## Technical statement

### Section 6.17. 125 MICRO MAX

Picture 1

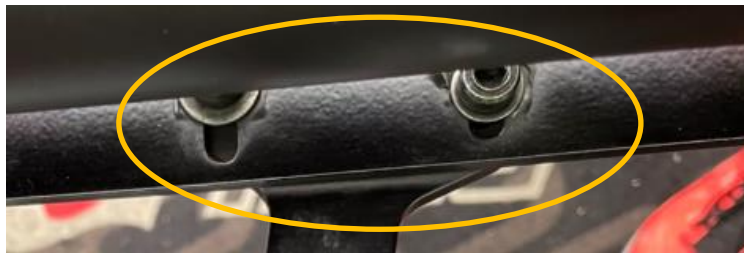
We have received the pictures below with your email sent on Monday May 10<sup>th</sup>, 2021. On the pictures 1 and 2 it is evident that the exhaust is mounted using a flexible mount – see highlighted sections - which allows movement in multiple directions.

The type of installation seen on the pictures is causing an infringement with the Global Technical Regulations 2021 (**see paragraph below**). This installation is **illegal to use according to the regulations**.

The Exhaust must be installed firmly to the chassis using a rigid mount/s. The Exhaust must be mounted to the rigid mount/s using 2 ROTAX silent blocks. (part 660920 and or 260657 allowed). The deflection of the 2 silent blocks is the only Exhaust movement allowed. The Exhaust must be mounted in a neutral position with no stress on the 2 silent blocks.
